Subject: P.H.O. APPLICATION NO. PHO-1-24--Z-22-23-4 – Notice of Pending Actions by the Planning Hearing Officer

APPLICATION NO: PHO-1-24--Z-22-23-4

Reason for Request: Request to modify Stipulation 16 regarding landscape area.; Request to delete Stipulation 18 regarding right-of-way dedication for 8th Street.

Subject: PHO Written Request

Title:
ENLARGED SITE PLAN

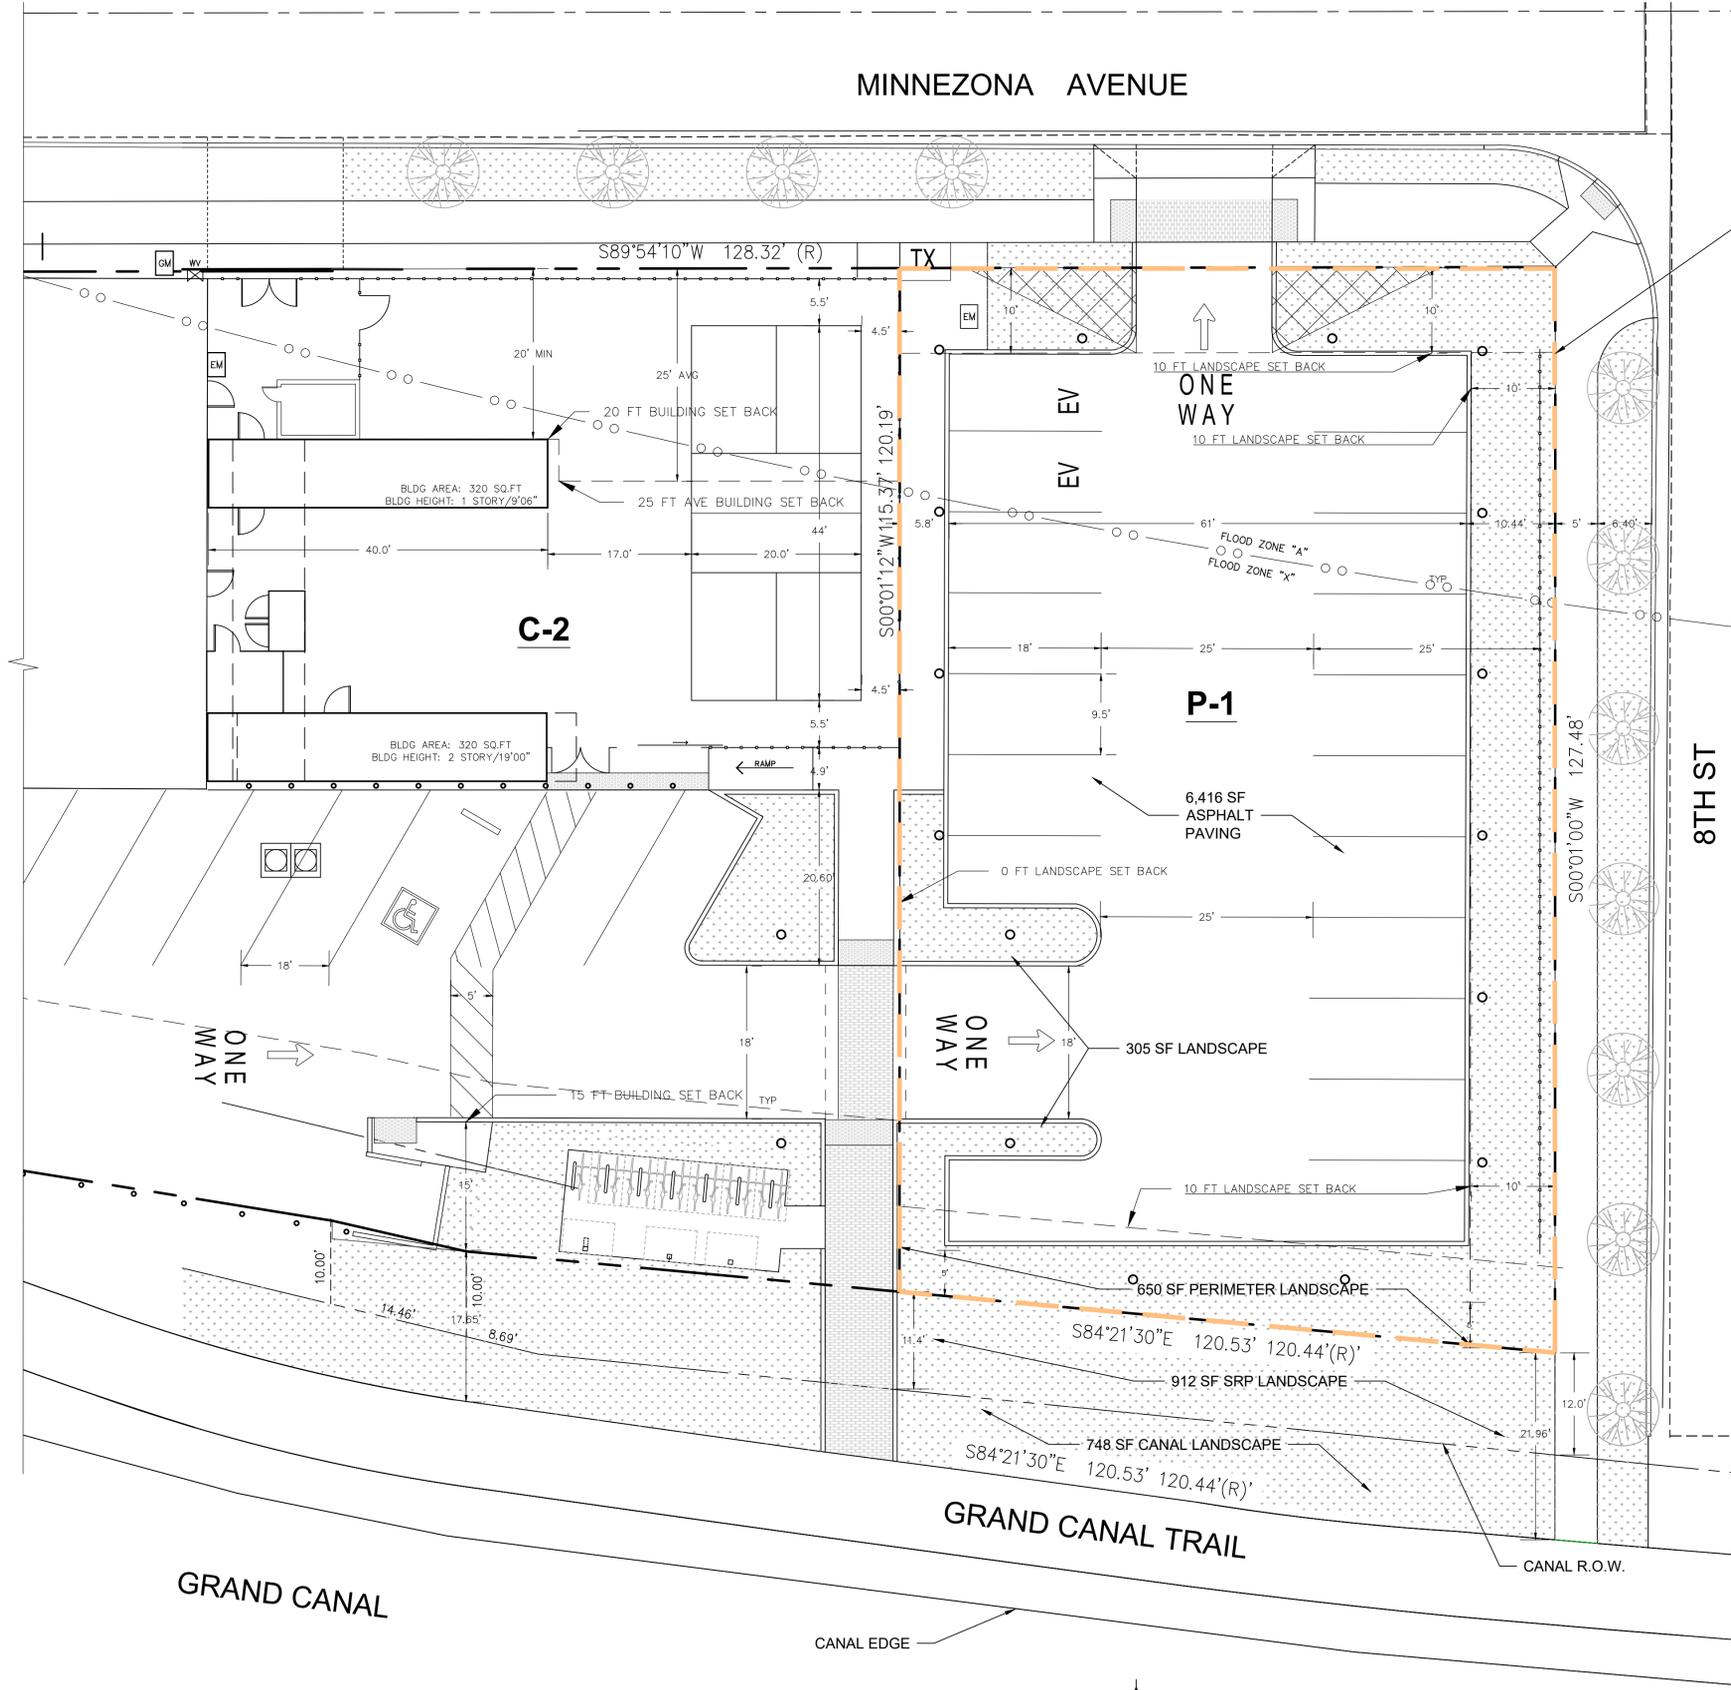
- 16. A minimum 5, average 10-foot-wide landscape ~~setback~~ **area** shall be provided from the south property line.

It is requested that stipulation 16 be modified to a landscape requirement that is not classified as a "setback" due to the extreme limitations placed upon landscape setbacks for development. It must be noted that the applicant is not opposed to providing landscape, but is promoting that the landscape count towards meeting stipulation 17 and other site development requirements required.

~~18. Right-of-way shall be dedicated for the west half of 8th Street for a half-radius 45-foot radius cul-de-sac dedication at its southern termination.~~

There is concern that Stipulation 18 does not appear feasible and conflicts with stipulations 14, 15, and 16.

The dedication will not only negatively impact the design of a sensible parking lot in P-1, but the actual completion of a 90' diameter cul-de-sac presents a major impact to the residents on the east side of 8th Street if it were to be built (See Enclosure 2). The city currently does not have a dedication of the other 45' half-radius required from the three lots to the east of 8th Street.

Furthermore, the cul-de-sac dedication at the termination of 8th street presents a conflict with property rights of the Salt River Project (SRP) who own the southern sliver of land. Enclosure 3, Sheet 2 shows that a portion of the requested

dedication will encroach on SRP property to include city improvements around the cul-de-sac.

It is proposed that this stipulation be deleted contingent upon the lot-line adjustment and replat to bring 8th Street in conformance with a maximum of 4 total lots on a dead-end street.
